Access Compliance Report

Public Rights-of-Way

Intersection ID: 13818	Main Street: CENTRAL_AV	Cross Street: SHERIDAN_DR	Location: NW
ADA ID: 179E4F6A439C	Ramp Type: Perp	Initial Pass/Fail: Fail	Overall Compliance: No
		Severity Score: 17.5

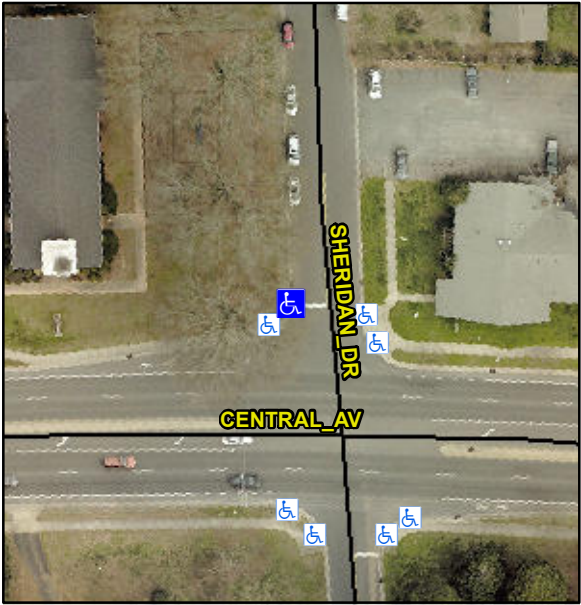
Codes/Mitigation Info/Possible Solution			Field Measurements/Component Compliance		
	Possible Solutions:		Compliance	Description	Data
	Remove & Replace Entire Ramp.		N/A	Ramp Length (in)	60.0
			No	Ramp Width (in)	32.0
			N/A	Flare Type LT	N/A
			N/A	Flare Slope LT (%)	N/A
			N/A	Flare Traversable LT?	N/A
			N/A	Landing Length (in)	N/A
			N/A	Landing Width (in)	N/A
			N/A	Landing Slope (%)	N/A
			N/A	Landing X Slope (%)	N/A
<p>Surveyor Notes:</p> <p>N/A</p> <p>PROW/ADA:</p> <p>Not Found, R304.5.1</p>			N/A	Flare Type RT	N/A
			N/A	Flare Slope RT (%)	N/A
			N/A	Flare Traversable RT?	N/A
			N/A	DWS Provided?	N/A
			N/A	DWS Contrast?	N/A
			N/A	DWS Length (in)	N/A
			N/A	DWS Full Width?	N/A
			N/A	DWS Offset (in)	N/A
			N/A	Shared Landing?	N/A
			N/A	Gutter Ponding?	N/A
			N/A	Gutter Lip Ht (in)	N/A
			N/A	Painted X Walk1?	No
				X Walk 1 Direction	To E
			N/A	X Walk 1 Width (in)	N/A
				X Walk 1 Slope (%)	0.4
				X Walk 1 X Slope (%)	3.6
